FILE NO. 12701

BRUCE - New depot

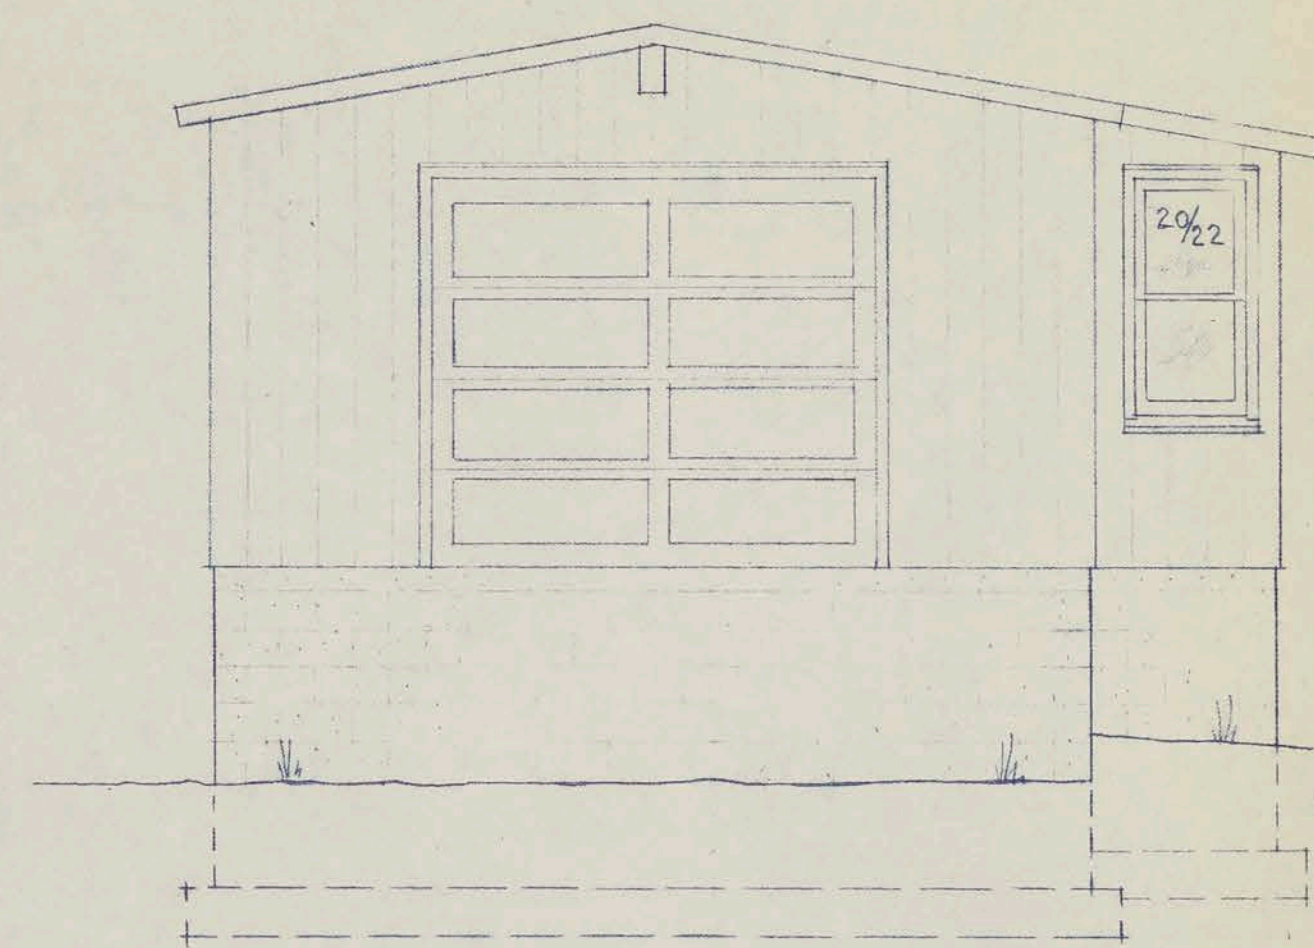
Referring to your letter January 9, File 12701,
submitting revised plan for the new depot at Bruce,
Washington:

The proposed plan dated January 8, 1964 is
satisfactory.
